Subject: Attn: Planning Officer Thomas Burns - RE: Development Application DA2020/1691

Attachments: 4SouthernCrossWay-Objection_DA2020-1691-FIN.pdf; 4SouthernCrossWay-Objection_DA2020-1691-Plans_ljrMarkup.pdf;

RE: Development Application DA2020/1691

New - Demolition works of existing dwelling and construction of dwelling house, secondary dwelling and studio at 4 Southern Cross Way Allambie Heights NSW 2100.

SITE ANALYSIS PLAN

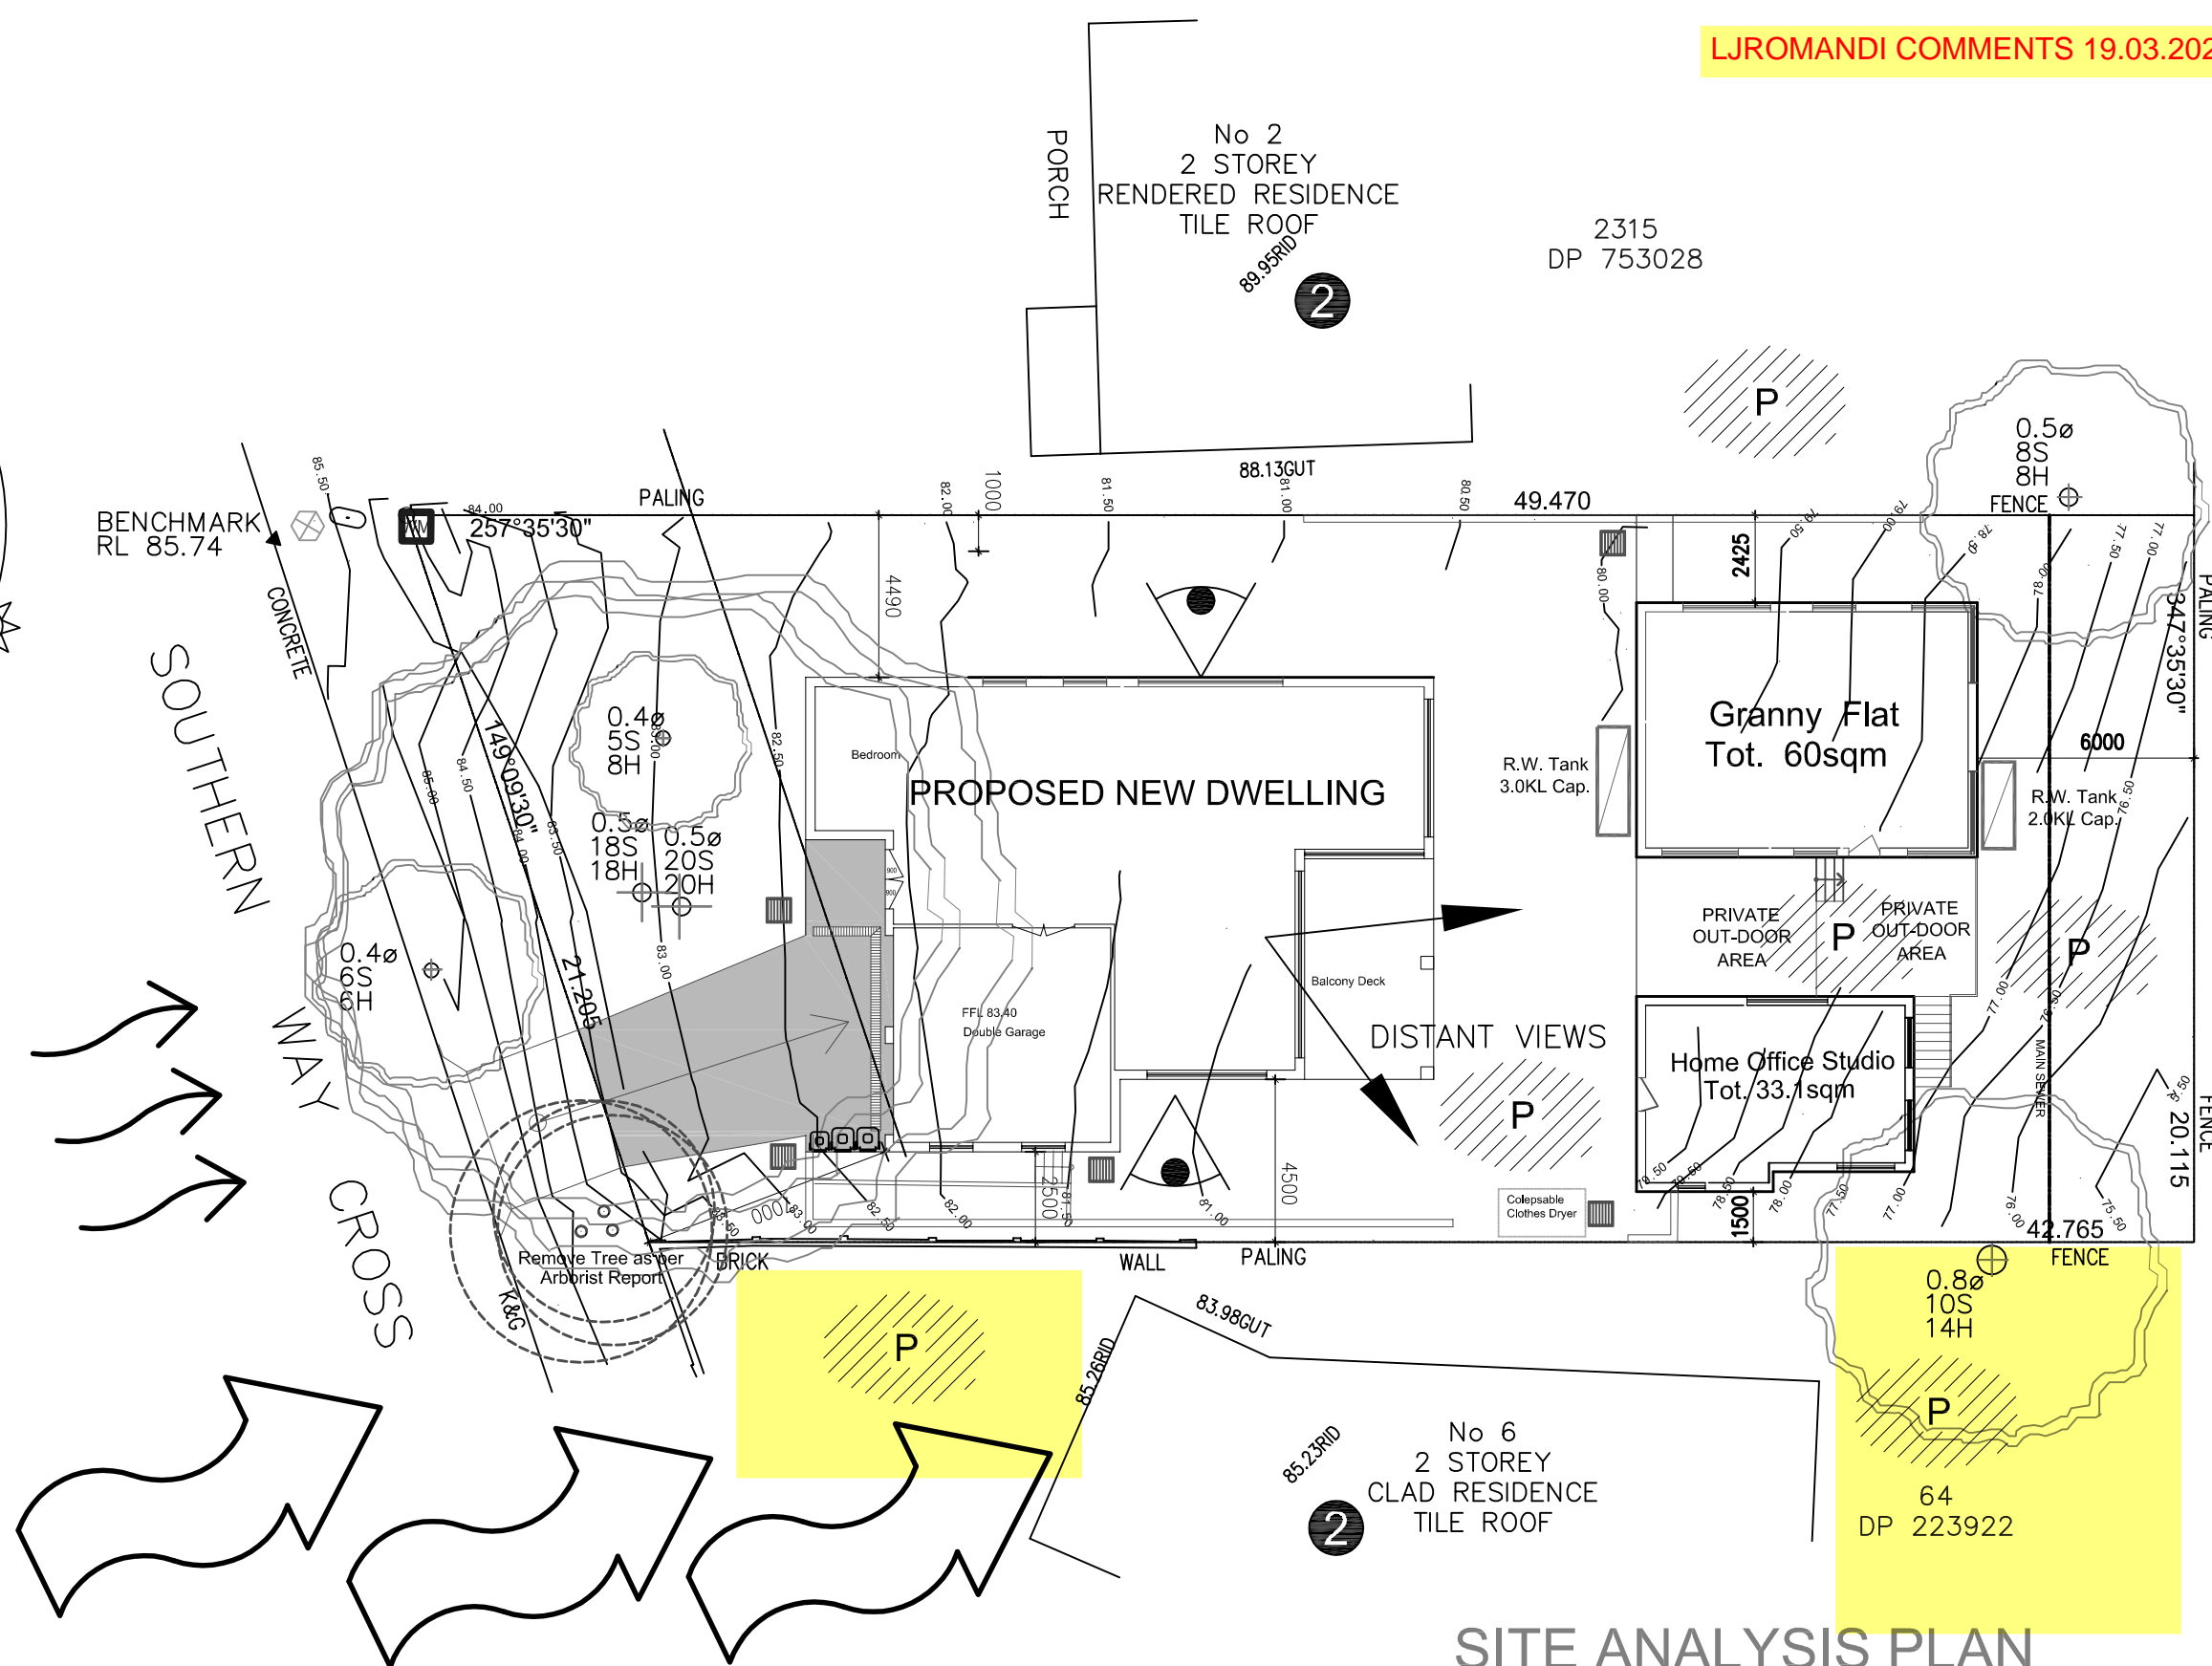
The Site Analysis Plan correctly identifies our '*Principal Private Open Space*', yet the shadow diagrams provided show a total disregard for these spaces. There are great degrees of overshadowing and privacy loss, from the main residence and the proposed home office to the East.

Our *Principal Private Open Space* design constraint, identified on the Site Analysis Plan, is totally ignored in the design of the proposed dwelling. Specifically overshadowing, reduced privacy and diminished solar amenity to;

**9AM SHADOW DIAGRAM
WINTER - JUNE 21**

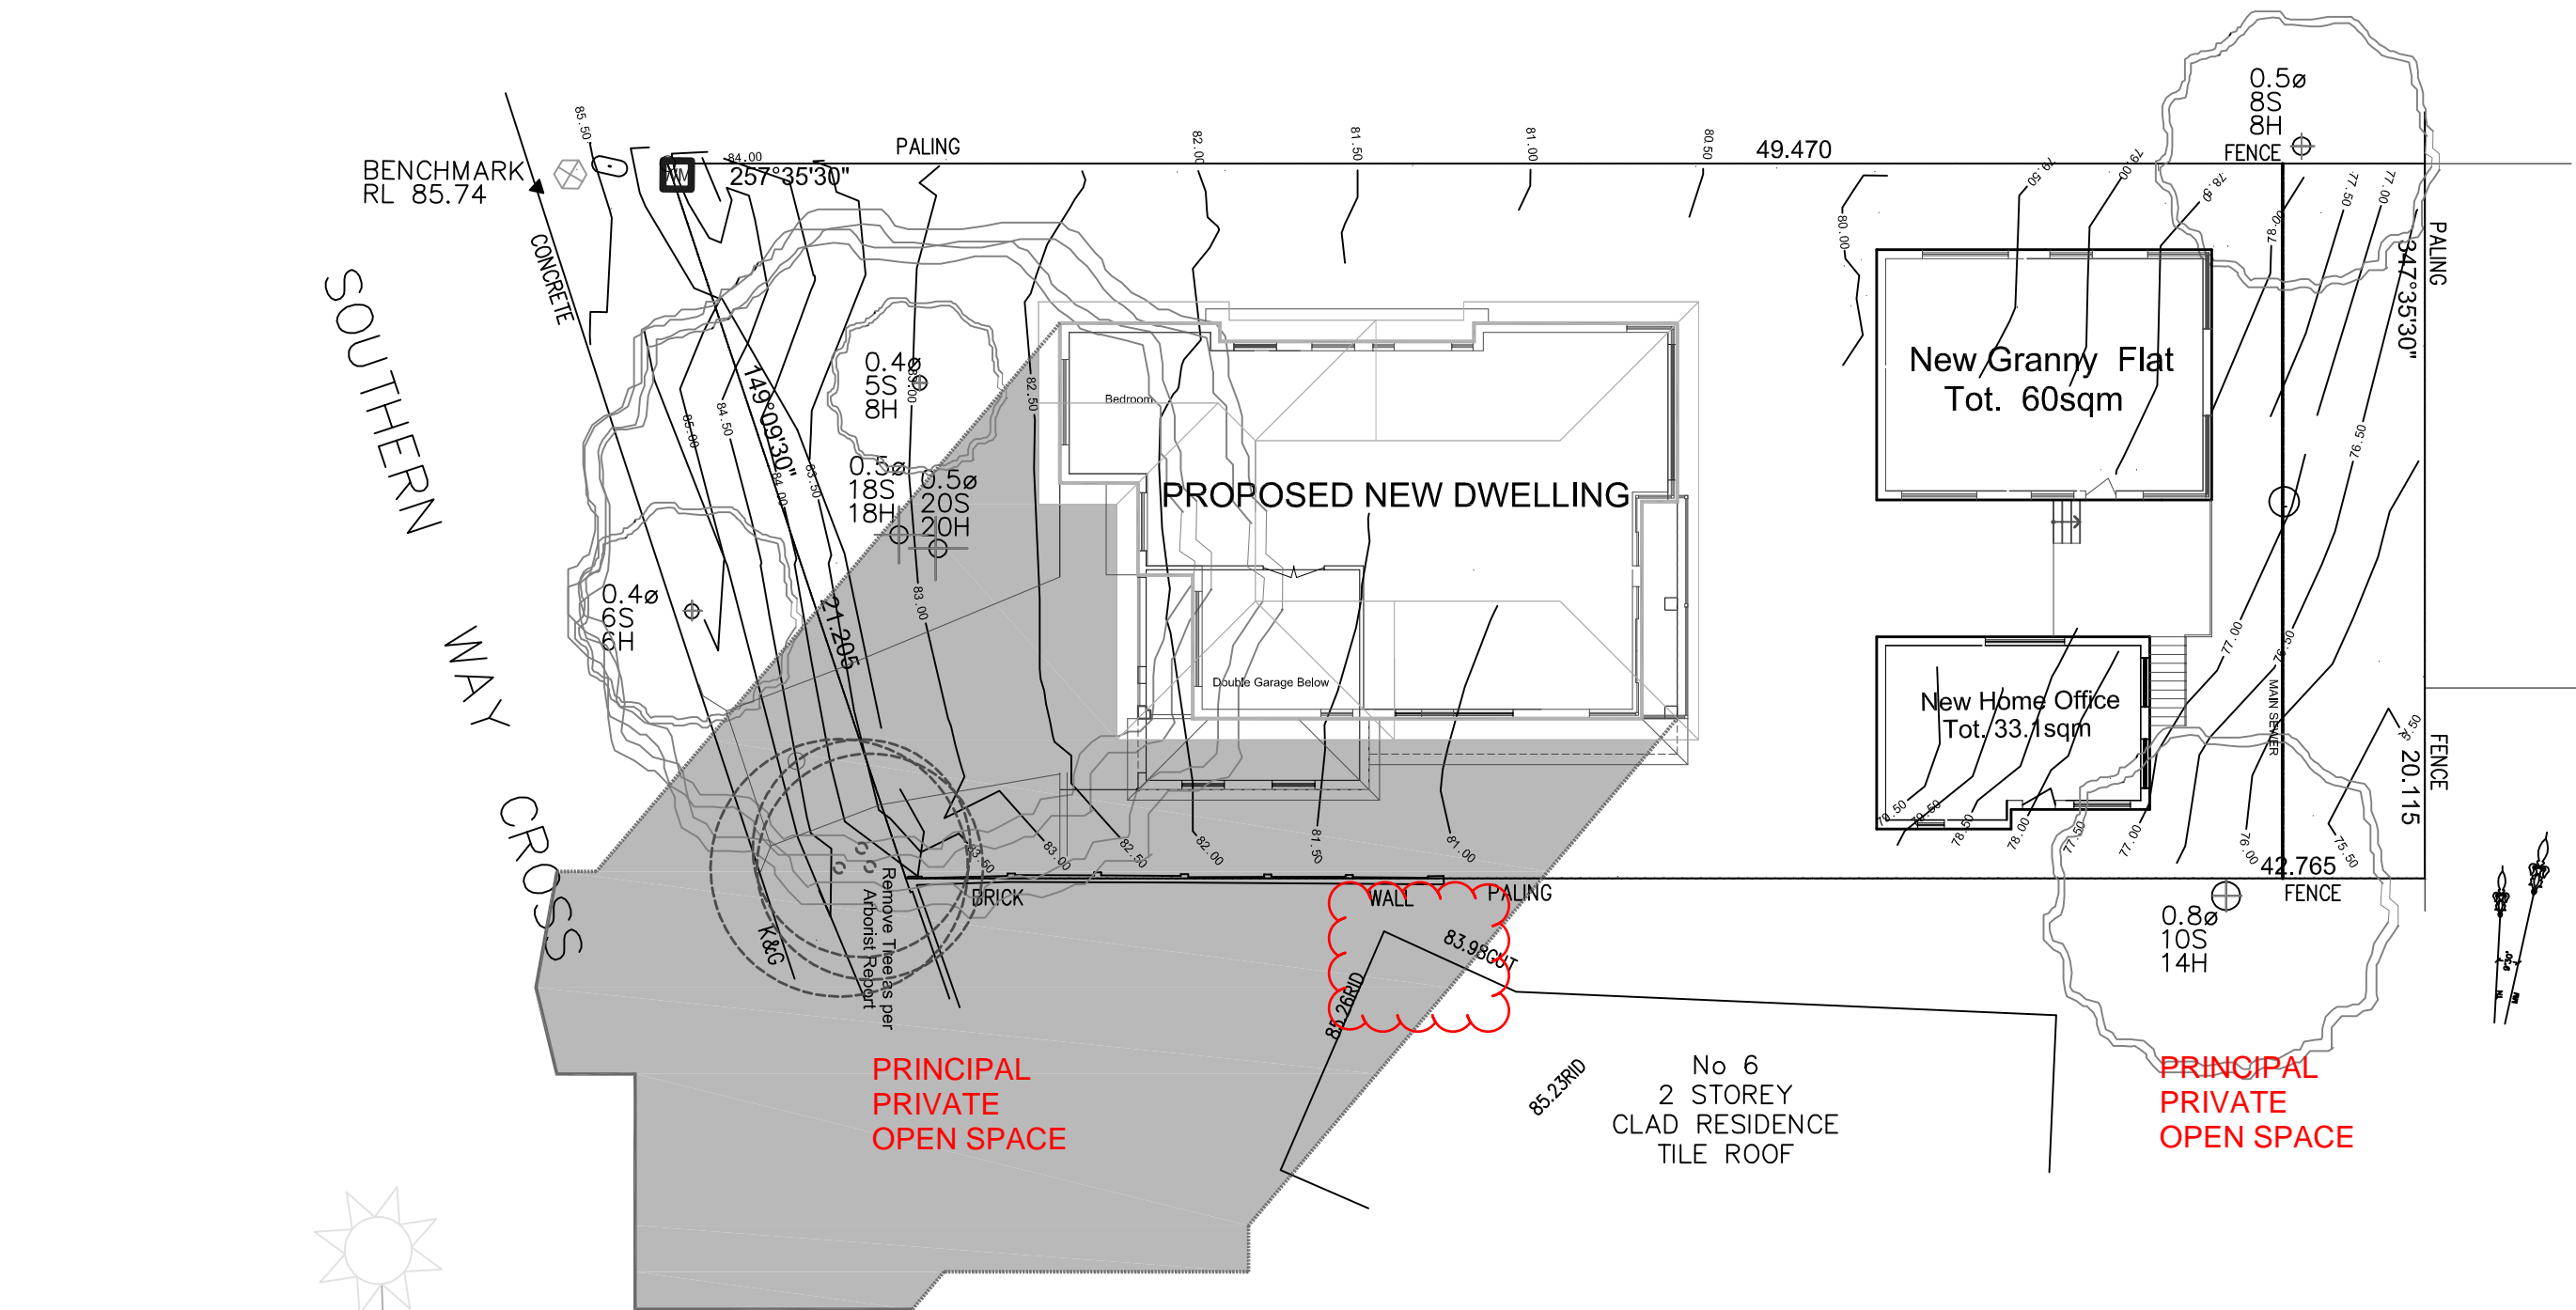
The shadow diagrams provided do not show sill height RLs or the locations of windows to our habitable spaces located on the Northern side of our home. We believe this information has been deliberately left off the diagrams as it would clearly show a significant loss of solar amenity to these habitable spaces.

Although only the Winter solstice shadows have been provided, it would appear that our swimming pool and front terrace area is cloaked by shadow for the majority of the day, only receiving sunlight ~2pm onwards, for what would be less than two hours. Similarly, the master bedroom and other habitable spaces on the northern side of our home would be completely obstructed from sunlight from 9:30am onwards.

LJROMANDI COMMENTS 19.03.2021

**NOON SHADOW DIAGRAM
WINTER - JUNE 21**

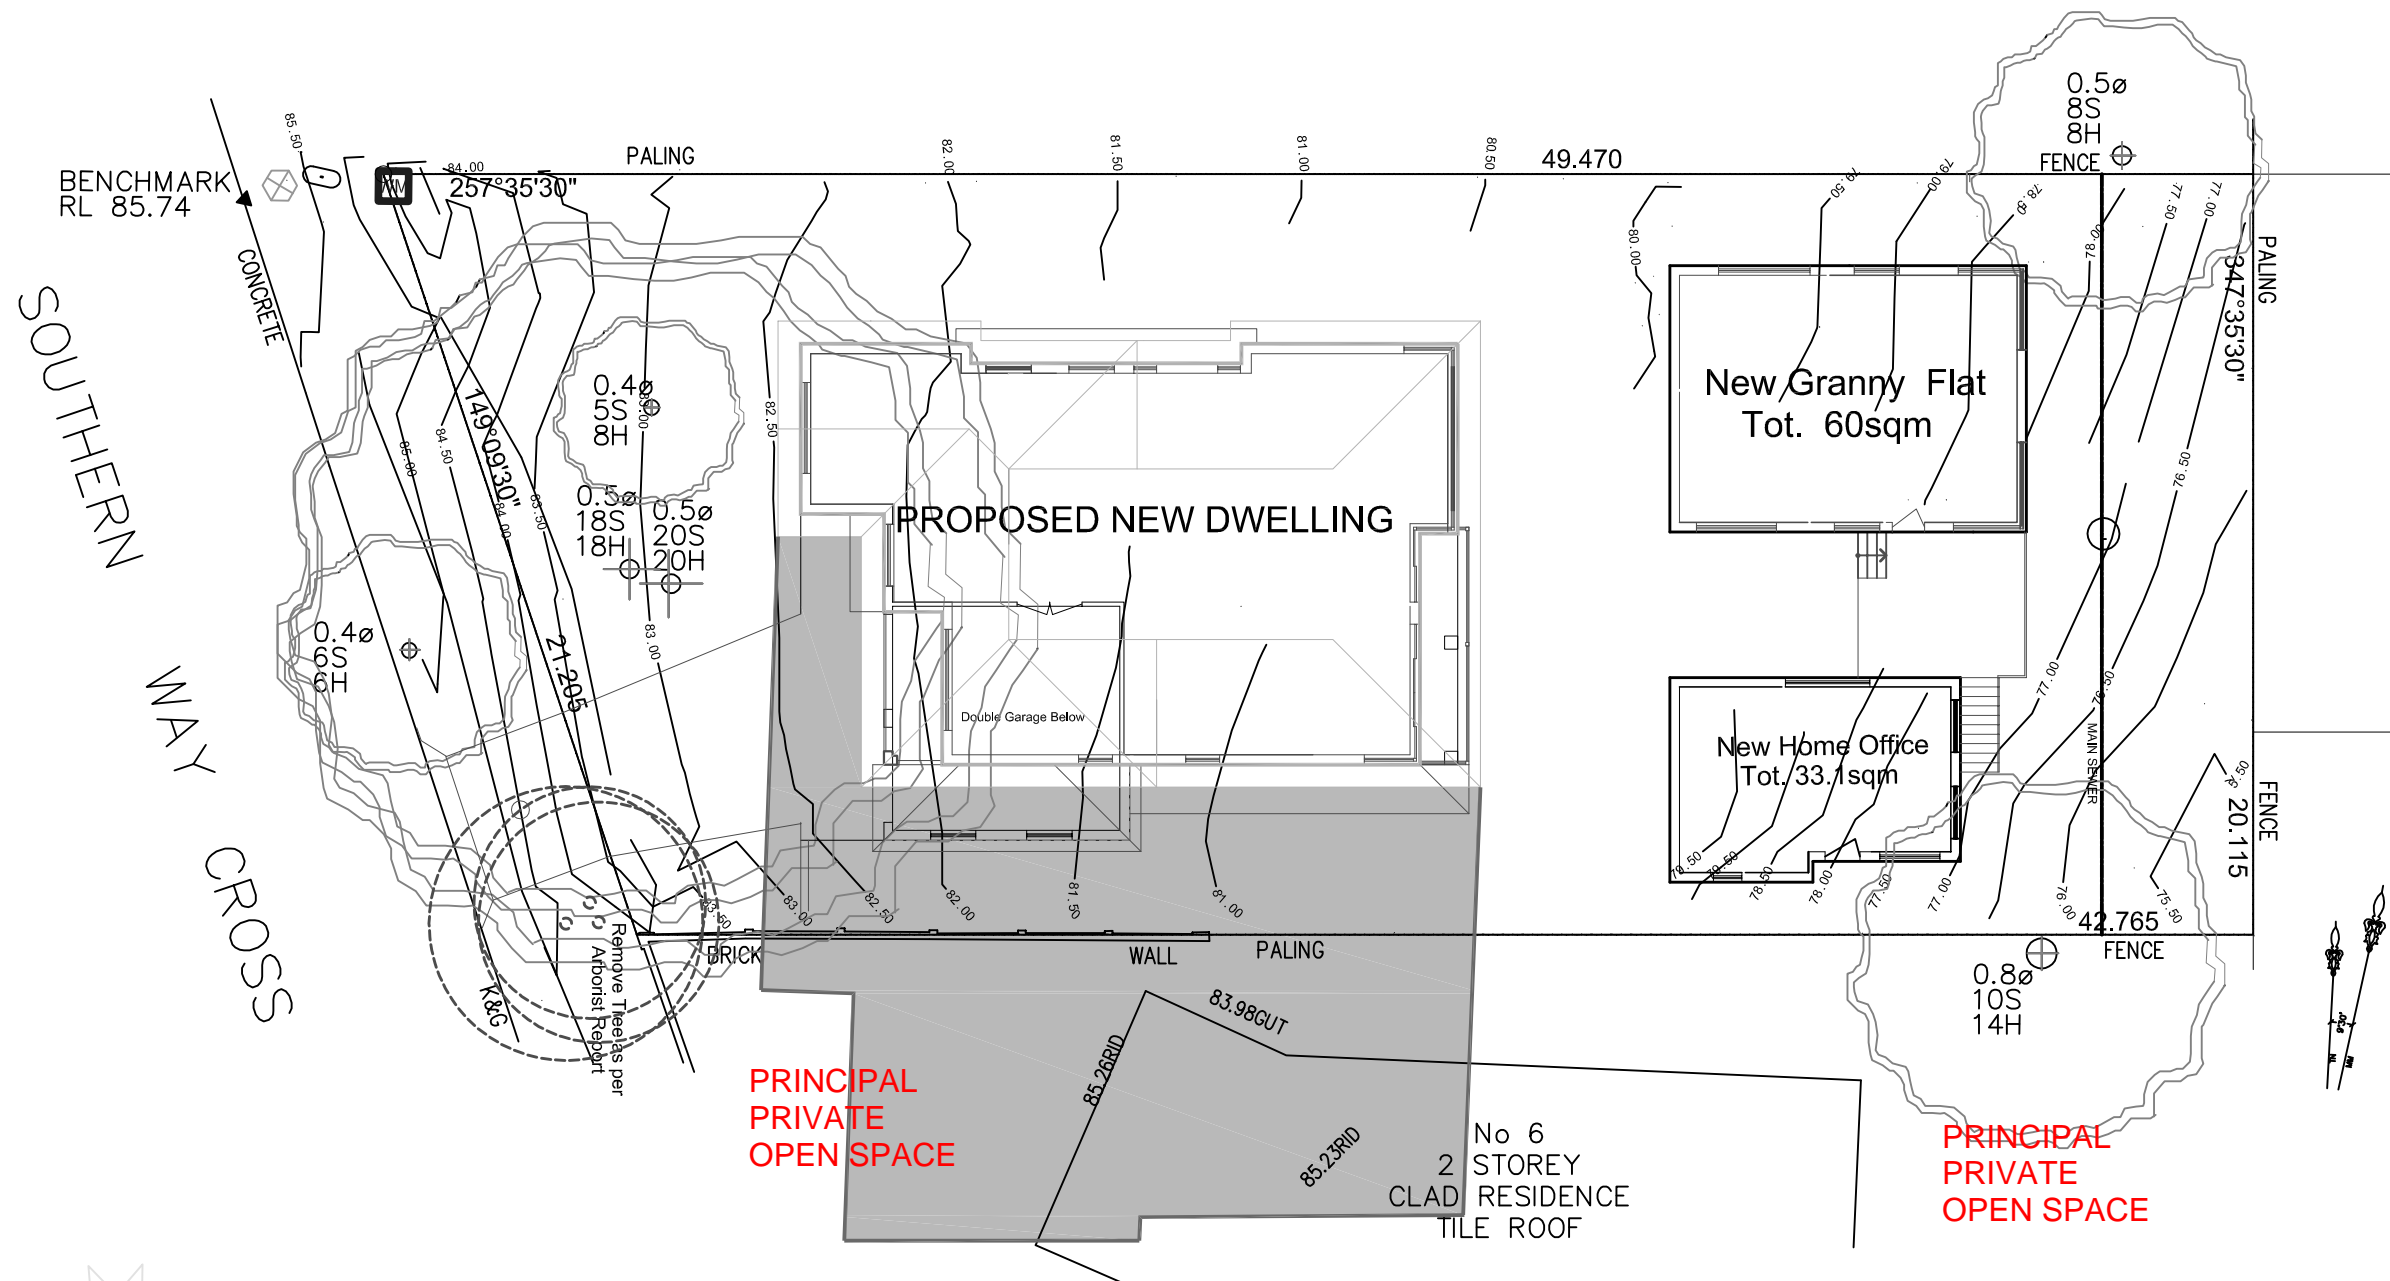
LJROMANDI COMMENTS 19.03.2021
